Safety Recall Notice 19V-659

SN675

MODELS AFFECTED: TL Aerials

SUBJECT: TL Upper Boom Cylinder Counterbalance Valve

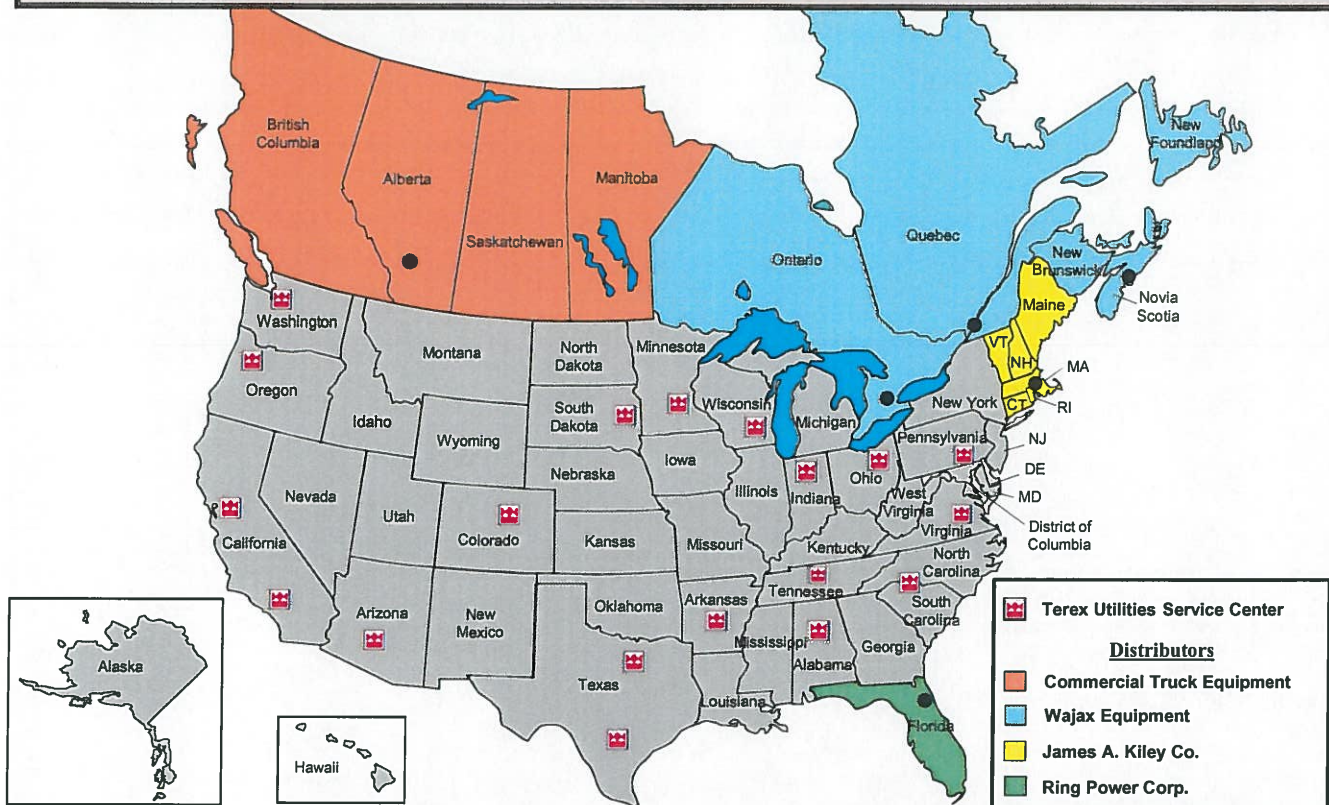
The counterbalance valve for the base end of the upper boom lift cylinder may have an incorrect holding valve on TL aerial devices manufactured from August 2, 2016 through February 14, 2017. **The upper boom may drift down when at maximum jib load if the upper boom raise hose should fail.**

Immediately inspect the upper boom lift cylinder. If the cylinder matches the view below, look at the holding valve cartridge closest to the base end of the cylinder. If the marking is CBBA-2000 the valve needs to be replaced.

Only TL units built with the cylinders as shown in the view above are affected. If an owner contacts you call TEREX Utilities at 844-837-3948 and ask for the warranty department for instructions and to arrange shipment of parts.

Terex will replace holding valve cartridges determined to have the incorrect setting at no cost to the owner. Field Service kit Z1564 will be provided to the nearest Terex Utilities dealer or Field Service Technician for installation on your unit if it is subject to this recall.

1. Perform the daily inspection with increased emphasis on the hoses of the upper boom cylinder.
 - a. If the hose is damaged do not use until the hose is replaced and this bulletin has been completed.
 - b. If no damage is evident you may continue to use the machine with reduced jib capacity not to exceed 50% at full extension.
 - c. If inspection shows the cylinder is subject to this recall have this bulletin completed within 30 days.
2. Always follow all inspection and maintenance requirements as specified in the manuals.
